Re: Draft Title V Permit [incorporating the Re-powering Action for Unit 5] 1270009-007-AV/1270009-008-AC/PSD-FI-270(A)

DRAFT COMMENTS for DISCUSSION PURPOSES SANFORD POWER PLANT 9/08/03

Re: Response to Department Request dated Oct. 10, 2002: Title V Permit Revision Request to incorporate the Repowering Action for Unit 5 1270009-007-AV/1270009-008-AC/PSD-FI-270(A)

Figure 6-2: HP Drum Temperature and Pressure During Cold Startup

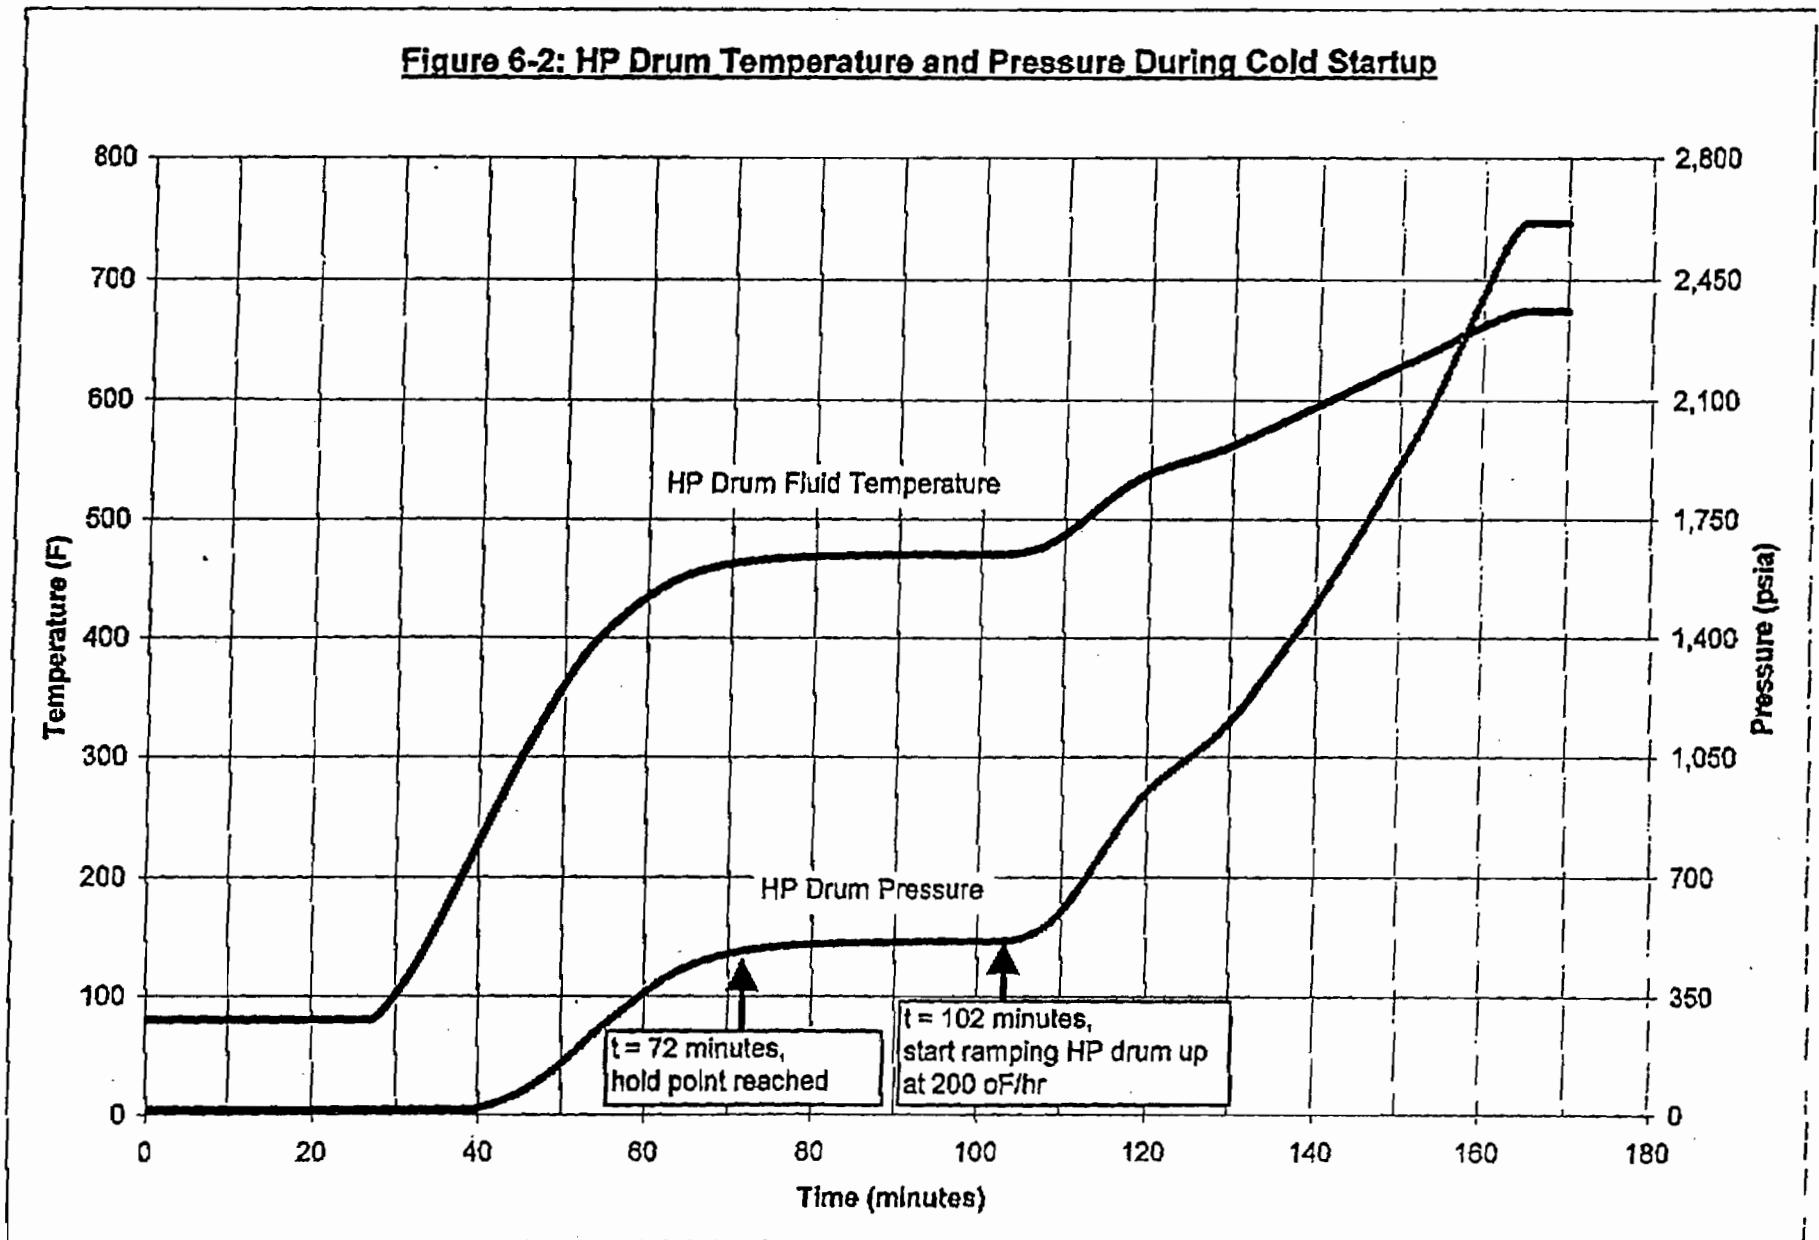
The second item concerns the supporting information regarding the proposed excess emissions language for the cold startup of the CT/HRSG systems. The Foster Wheeler requirement for cold start is found as paragraph, 6.3.3 Cold Start. In addition, the heat soak requirement specified by Foster Wheeler is found in paragraph 6.3.3.7. The HP Drum Temperature and Pressure During Cold Startup is shown as Figure 6-2. This information is attached [Attachment 2]

- 6.3.3.7 It is imperative that the HP drum pressure be held at 450 PSI for a minimum of 30 minutes in a "soak period" to allow for the equalization of thermal stresses on the unit, as shown in Figure 6-2.
